Invited Further Response to the 'Water Statement of Common Ground'

By:	Dr Michael Rivett FGS (Director, GroundH ₂ O Plus Ltd)
Date:	27 November, 2021
Use:	Appeal APP/M1900/W/21/3278097 (Nov. 2021) on rejection of proposed quarrying activity, Hatfield Aerodrome
Witness called by:	Ellenbrook Area Residents Association (EARA) and Smallford Residents Association (SRA)

Fig. 1. Bromate concentrations at monitoring points BH308 and BH105 around the plume core remote from Site.

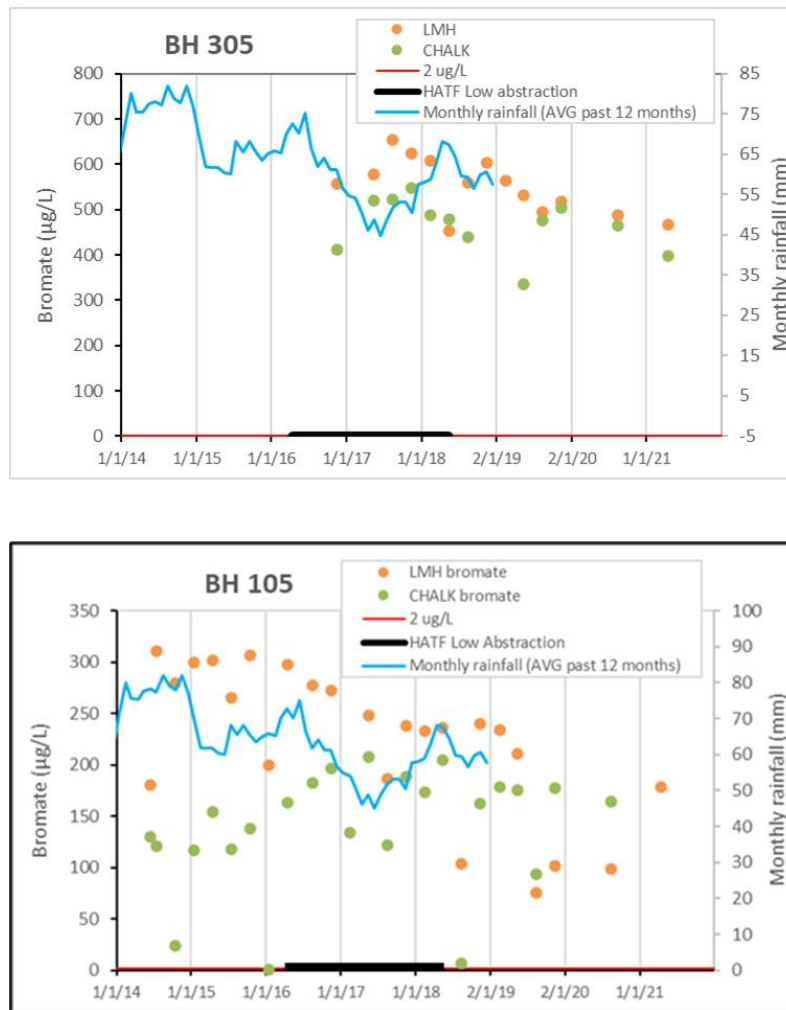
Examining boreholes in the main plume core area north of Site (Fig. 1):

- **BH305**, of all the boreholes examined, shows greatest similarity of bromate in the LMH and chalk suggestive of hydraulic continuity between them in the plume core. Bromate concentrations there would have had long timeframes to achieve stable interactions which will decline towards the plume margins. The LMH exhibits higher bromate concentration than the chalk that possibly relates to greater source terms of bromate still residing at shallower horizons nearer the bromate source.
- **BH105** likewise shows generally higher (to around double) concentrations in the LMH compared to the chalk underlining the importance of LMH to storage of bromate plume mass. In contrast to BH305, temporal trends are notably different in LMH and chalk, in fact opposing at times. This does not suggest much continuity between the chalk and LMH here and different controlling processes.

Fig. 2. Bromate concentrations at monitoring points BH108, BH201L and BH104 located increasingly close to the quarry Site.

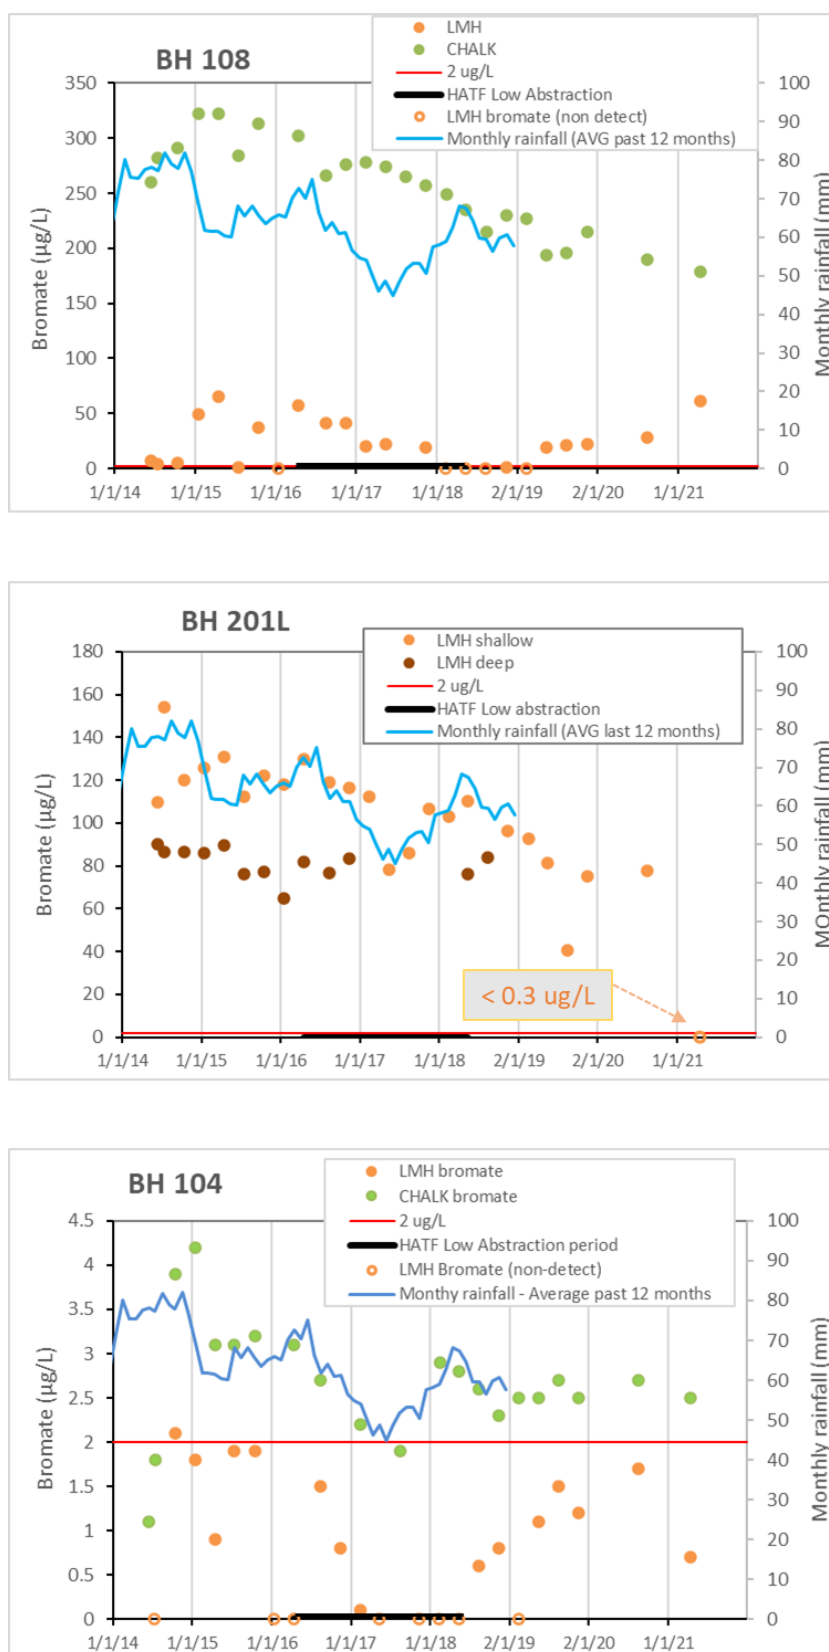
Examining the boreholes located increasingly closer to the Site (Figure 2):

- BH108.** LMH bromate appears anomalously low compared to the chalk relative to other boreholes. LMH bromate does not fit spatial concentration trends. For instance BH201L closer to the Site has higher concentration illustrating the spatial heterogeneity (variability) of the plume and raises issues in reliable contouring the plume edge with limited data. Trends are notably different in the LMH and chalk and do not suggest local hydraulic continuity. Chalk shows a declining trend overall that is not shown by the LMH; in recent times bromate is increasing as chalk declines. I would maintain that the LMH bromate concentrations displaying a consistently low bromate during the 2016-18 Bishop's Rise low abstraction period may be influenced by changes in that abstraction rate (recognising too other influences may co-occur). Bromate appears to gradually decline during abstraction low followed by a gradual increase over 2 to 3 years back to pre-low-abstraction period concentrations as pumping increased. This may be very reasonably interpreted as a SLOW lateral drift of the plume transversely across 108 in the LMH back and forth, away from and then towards the quarry Site in response to decreased abstraction and northward plume drift and

- BH201L** - Comparison is of shallower and deeper points in the LMH. The borehole is very close to the Site perimeter and shows much higher concentrations around 100 µg/L bromate than BH108 (see above) laterally closer to the plume core. Hence this discrepancy shows heterogeneity, discontinuous variability of the plume edge and requirements for high spatial resolution to reliably contour that plume edge. Bromate in the shallow LMH is consistently higher and more variable than the bromate in the deeper LMH – showing the importance of increased shallow contamination in the LMH. Together they suggest high bromate concentrations occur over the LMH thickness to around 50 times the 2 µg/L plume threshold very close to site. Such contamination may likely be drawn in to Site by any quarry abstraction from the LMH. Deeper LMH shows quite constant bromate and contrasts with the shallow LMH bromate that exhibits declining bromate with time. The shallow LMH appears to show correlation with rainfall, but with increased bromate often observed with increased rainfall – this is the opposite relationship to rainfall indicated in the SoCG. This correlation may suggest increased leaching of shallow source area bromate up gradient by higher groundwater levels in response to increased rainfall that is captured by this scale of shallow monitoring. It shows the importance of near site LMH gravels receiving shallow contamination from the Chalk up gradient that results in bromate concentrations extremely close to the quarry site at very high concentrations. Relationships to the reduced Bishop's Rise abstraction period are not obvious. SLR flagged the significance of recent low concentrations detected near Site (in Conditions discussion) exemplifying 201. However, this refers to a single isolated sample in 2021 below detection limit (Fig. 2) that on first inspection would appear very anomalous. It would certainly require confirmatory sampling, especially given the lower sampling frequency of late. Little weight could be given to that sample at present without further sampling.

- BH104** - boreholes are located at the Site NE corner perimeter and show Chalk bromate at 2 – 4 µg/L just above a 2 µg/L plume threshold and LMH bromate usually below, but approaching the 2 µg/L threshold. Trends again are notably different in LMH and chalk and do not suggest local hydraulic continuity between them and somewhat separate plume migrations in the chalk and LMH at the plume margins (which would be reasonable to expect hydrogeologically). A relationship to rainfall is not obvious for LMH but is for the chalk. Again, this is the opposite correlation observed at this local scale to that indicated more generally in the SoCG. Again, higher rainfall and higher water levels exhibiting higher bromate suggesting again the importance of leaching shallow source zones of bromate at high water table. A relationship of the 104 LMH bromate to the HATF (Bishop's Rise) low abstraction 2016-18 period, although questioned by AW, does appear a valid interpretation to consider. Similar to 108, bromate appears to gradually decline during the abstraction low followed by a gradual increase over 2 to 3 years back to the pre-low-abstraction period concentrations as abstraction increases. This may be reasonably interpreted as a slow lateral drift of the plume transversely across 104 in the LMH back and forth away from

and then towards the Site (recognising other processes may co-influence concentrations). If correct, then linking of increased Site bromate with increased and sustained Bishop's Rise abstraction rates has important Site implications, i.e. sustained pumping at even higher pumping rates may draw yet higher bromate concentrations into the Site. I do concede that some of the LMH bromate non-detects do not fit my interpretation, but would be interested to establish actual pumping conditions at actual sampling. Continued 104 monitoring with Bishop's Rise pumping at 5 MI/d would be illuminating – if concentrations maintain around 2 µg/L without low concentrations this would add weight to my argument. If frequent low concentrations occur then other controlling processes are (also) significant.

Fig. 4. Borehole 061 bromate concentrations with time shown in relation to 2014 and 2019 bromate plume maps taken from SLR reporting.

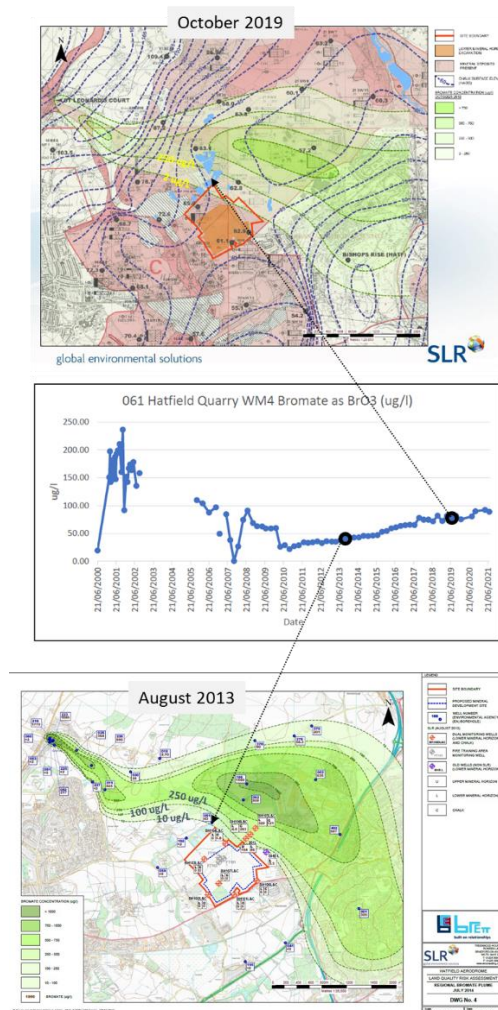
I questioned in ID-15 the SoCG claimed stability of the plume, for instance the bromate concentration ratios between the LMH and chalk are quite variable (page 14 of ID-15). Included within ID-15 (but failed to raise in the Appeal) is a plot of bromate concentrations in borehole 061 (Hatfield quarry) located to the immediate north-east of the proposed quarry Site that is shown alongside bromate plume figures shown for 2014 and 2019 in Figure 4. Bromate shows very high concentrations local to the Site that exhibit an unusual U-shaped profile with concentrations very steadily rising over the decade since the 2010 low point and now reaching around 100 $\mu\text{g/L}$ with some plume lateral expansion towards site evident when comparing the 2014 and 2019 plumes. Given concentrations approached 250 $\mu\text{g/L}$ historically, and the plume flowlines from this point skirt along the edge of the quarry development it is important to understand the controls on the bromate concentrations observed at this monitoring point. My guess is that these gradual trends in bromate with time are abstraction variation related(?). Understanding this concentration profile with time appears critical to understanding the temporal trends in bromate in the immediate site vicinity and possible bromate plume entry into the Site area.

Fig. 5. Conceptual model of increased abstraction at Bishop's Rise from typical 5 ML/d to 9 ML/d (licensed rate) potentially causing slow plume reorientation through part of the quarry Site (note the flow diversions are illustrative of the concept, not actual or modelled).

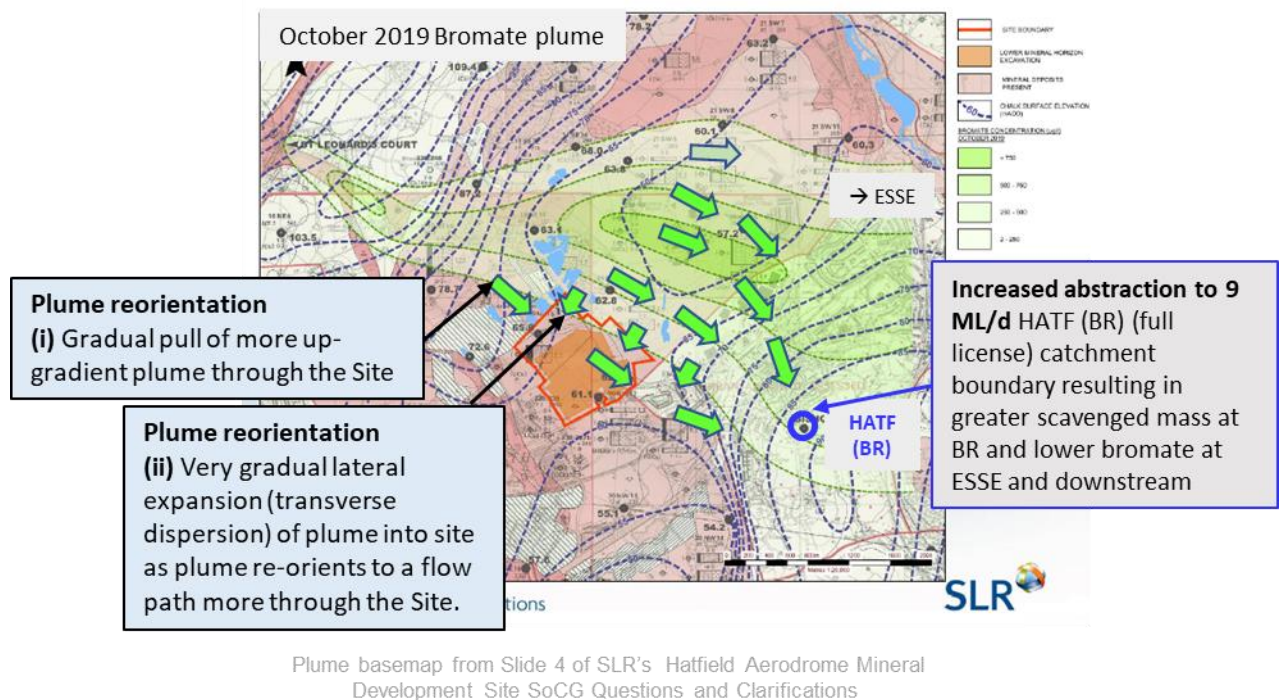
Conceptual model of the issue – In my opinion the evaluation of increased Bishop's Rise abstraction rates should consider more carefully that the bromate plume may be displaced slowly sideways with increased Bishop's Rise abstraction rates, moving south and perpendicular to its main flow direction. The banana-shaped plume is being slightly straightened on its inside bend, towards Site, causing a gradual lateral drift into the site at the north east (borehole 104) boundary. Fig. 5 shows a conceptual model of the possible influence of increased abstraction at Bishop's Rise from the typical 5 MI/d to 9 MI/d (licensed rate) potentially causing slow plume reorientation through part of the quarry Site. Two components of plume reorientation are depicted: (i) a Gradual pull of the more up-gradient plume through the Site; and, (ii) Very gradual lateral sideways expansion (transverse dispersion) of plume into site as plume re-orient to a flow path more through the Site. On (ii), the sideways motion of a plume is difficult as, technically, transverse horizontal dispersion (sideways spreading) of plumes is a weak process. It will be more difficult to re-align the bromate plume sideways in the LMH gravels than the chalk as the hydraulic gradients are less (as more removed from the chalk adits influence, gravels have higher (mobile porosity) storage than the chalk). Within the LMH itself, plume sideways motion will be more difficult in the lower permeability sands than in the gravels and may be one reason why LMH boreholes are showing different responses to Bishop's Rise pumping (Figures 1 and 2). The predominant orientation of individual beds ('lenses') of gravel, sand and silt sub-deposits will be significant. If elongated bed directions are aligned with flow directions encouraging flows along them, or if perpendicular inhibiting flows and lengthening timeframes.

In the absence of convincing evidences, the 'acid-test' would be for Bishop's Rise to be pumped at 7-9 MI/d continually for at least a year, ideally 2 years or more, continuing quarterly (at minimum) baseline sampling of monitoring wells. This would be the only reliable way in my opinion of safeguarding the option to operate the Bishop's Rise scavenger well at its full 9 MI/d rate and verify if the bromate plume does, or does not migrate on to the Site at those rates. If the plume is shown to migrate on to Site at those abstraction rates then the proposed quarrying would jeopardise scavenging system capability due to the installation of backfill that would interfere with that subsequent remediation performance and scavenge of LMH bromate. Also, for the quarrying then to be viable, it would rely on the discretion of AW not to operate Bishop's Rise at high 7 – 9 MI/d rates that may cause bromate plume invasion to parts of the Site. Prior to such a high-rate abstraction test, continued Site quarterly

monitoring with Bishop's Rise abstraction consistently continuing at 5 ML/d is essential to fully confirm bromate current plume – Site interaction behaviour at those abstraction rates for a prolonged period.

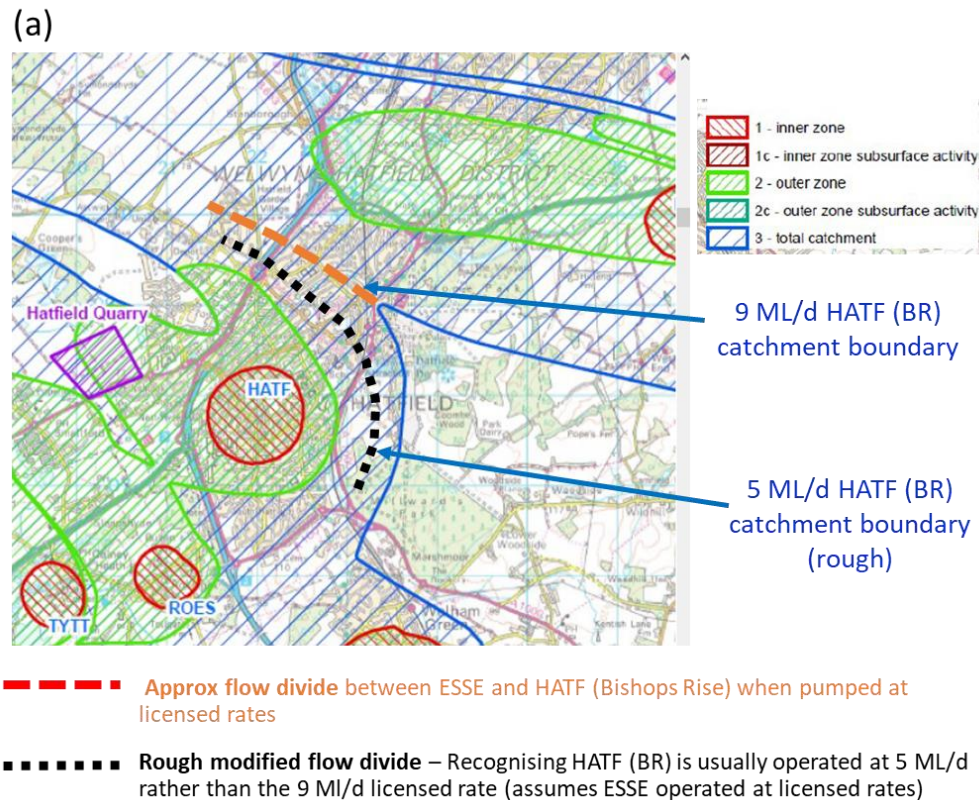
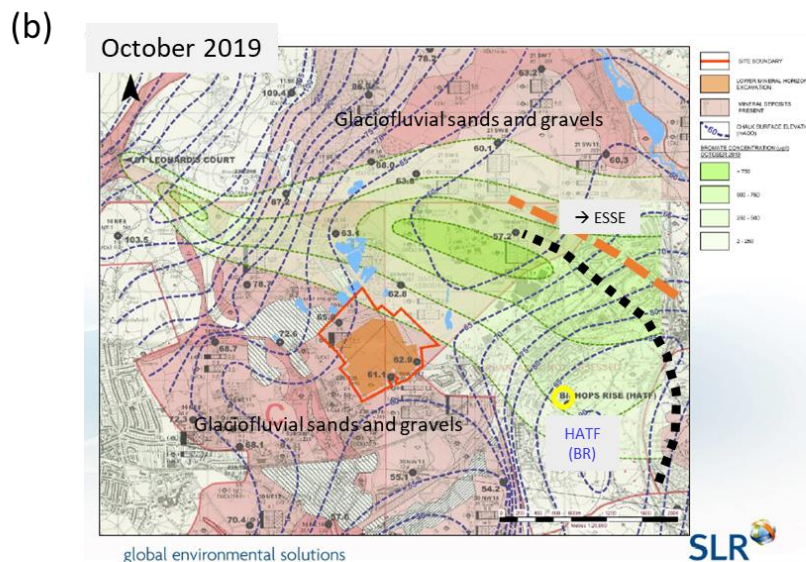
Figure 6a shows the source protection zone (SPZ) base map annotated with approximate flow divides between groundwater flowing to Bishop’s Rise (HATF) versus ESSE (Essendon) for: licensed (9 ML/d) and more typical 5 ML/d abstraction rates for Bishop’s Rise. The lines are approximate, especially the later which presumes ESSE is maintained at its licensed abstraction rate. The main point on the 5 ML/d flow divide line is that the capture zone of Bishop’s Rise will be somewhat reduced, less extensive from the abstraction. Fig. 6b plots the approximate flow divides shown on a base map of glaciofluvial sands and gravels (i.e. U/LMH) and bromate plume. Based on this conceptualisation, some of the bromate plume in the gravels (the plume presumed to lie approximately above the shown chalk plume where the gravels are present) will be drawn towards Bishop’s Rise and some towards ESSE (and possibly down gradient

captured by neither abstraction). A lower proportion would be captured by Bishop's Rise pumping at its typical 5 MI/d than would be at its full licensed rate.

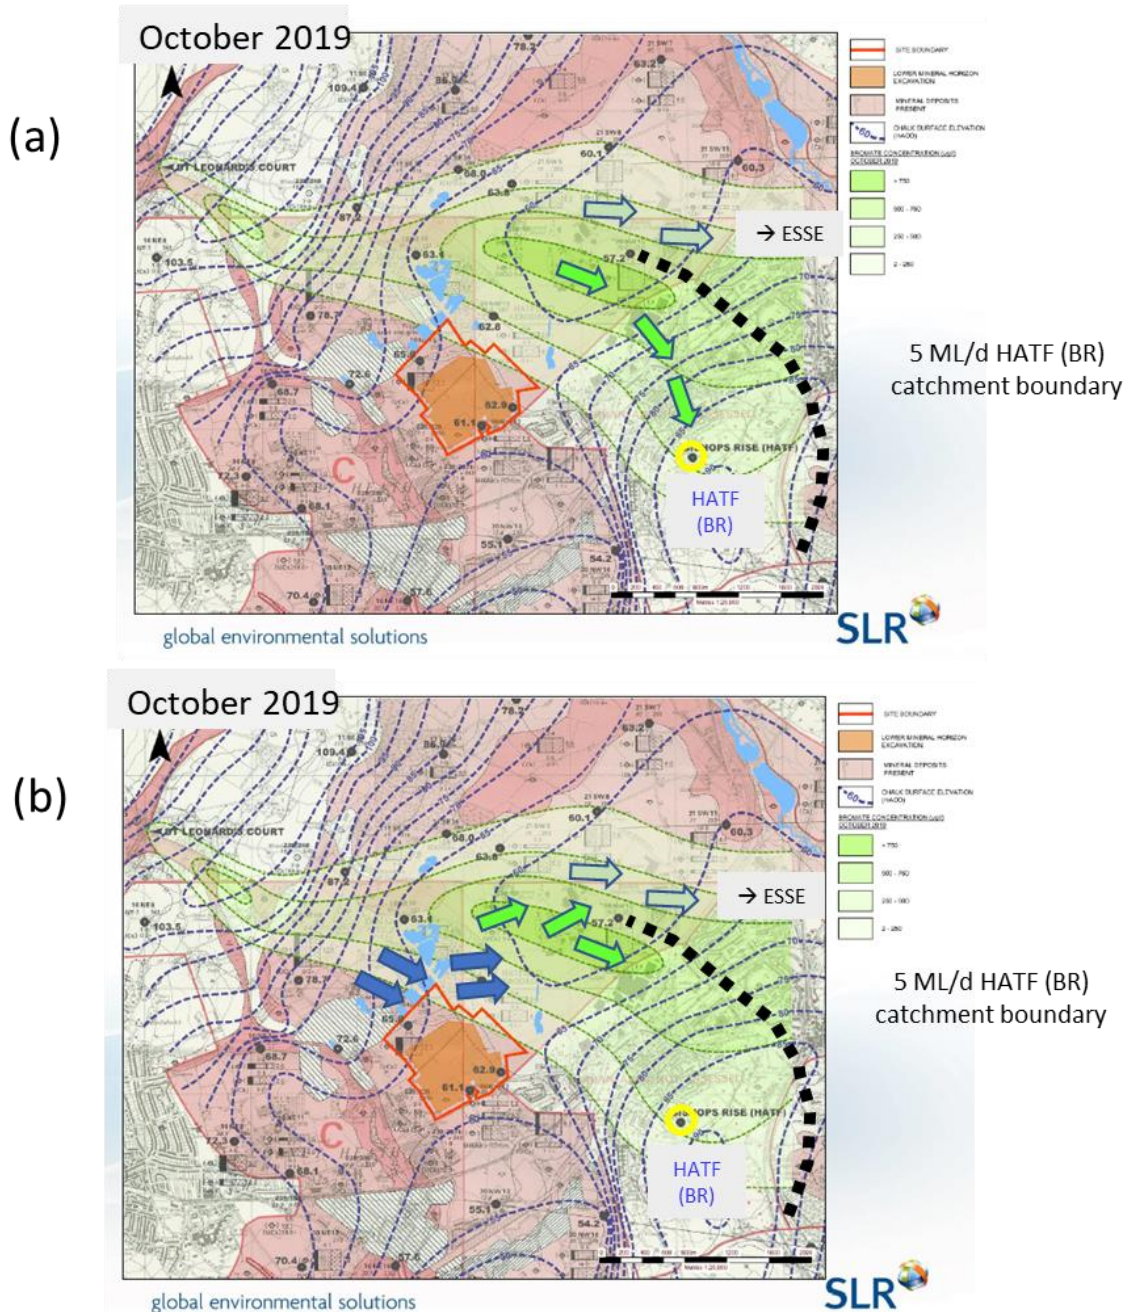
Figure 7 extends Figure 6b with the addition of arrows conceptualising the bromate plume split. Figure 7a depicts existing flow conditions and approximate catchment for 5 ML/d abstraction at Bishop's Rise and Figure 7b showing schematic illustration of displaced plume bromate arising from groundwater flow diversion in the LMH around the low permeability backfill. The profile in the plume core, the bend southwards, would support that the shown capture zone split is likely in the right region, at least approximately.

- Groundwater flow calculations if done using the transmissivity values and gradients in the SLR reporting for the LMH would indicate a significant volume of groundwater flow will be diverted around the low permeability backfill.

- The split between flow underneath and around is unknown, noting that local hydraulic continuity with the chalk cannot be presumed for flow underneath and may locally vary with connectivity to the more horizontal chalk fractures transmitting flow.

- Current hydraulic gradients suggest most flow diversion would occur northwards towards the main bromate plume and will inevitably lead to some displacing – shunting of the bromate plume northwards by likely cleaner groundwater diverted around the backfill.

- Monitored bromate concentrations on or near the site perimeter will likely reduce.
- The 5 Ml/d capture zone shown in Figure 7b is likely very close to the high bromate concentration plume core and hence capture of these high concentrations. Hence, if the shunt in groundwater and plume northwards, if conveyed that far north, may lead to high concentration portions of the plume near the core evading capture by Bishop's Rise.

- A key question is then will the groundwater displacement effect be sufficient to reach and displace concentrations beyond the capture zone reach. I agree it is a long way, but again the flow diversion is potentially quite large and will be influenced by the direction of the bedding of the gravels, which if aligning with the paleo-channel direction that could be assumed as a first approximation (Fig 7 basemap contours trending from South-west to North-east), would align favourably to push the plume north-eastwards as shown. The influence would be best numerically modelled to establish its preliminary significance or not.
